TECHNICAL TIP

DATE: May 29, 2014

SUBJECT: Traverse HCDU - Change from 36V to 24V

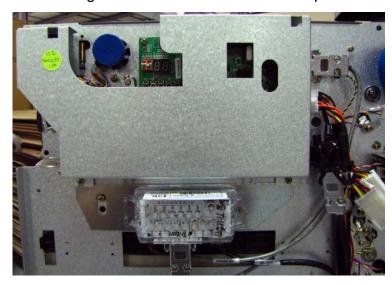
3. Remove the four screws that secure the main board cover. Set the screws and cover aside for reinstallation.

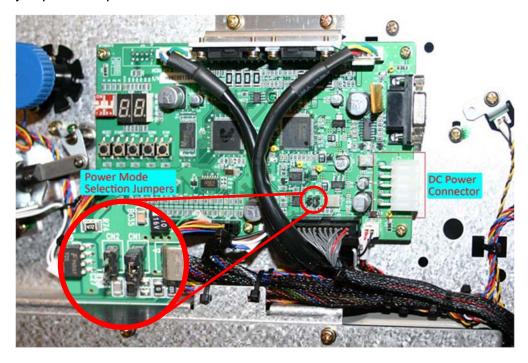
4. Move the jumper from port CN2 to CN1. Reinstall the main board cover.
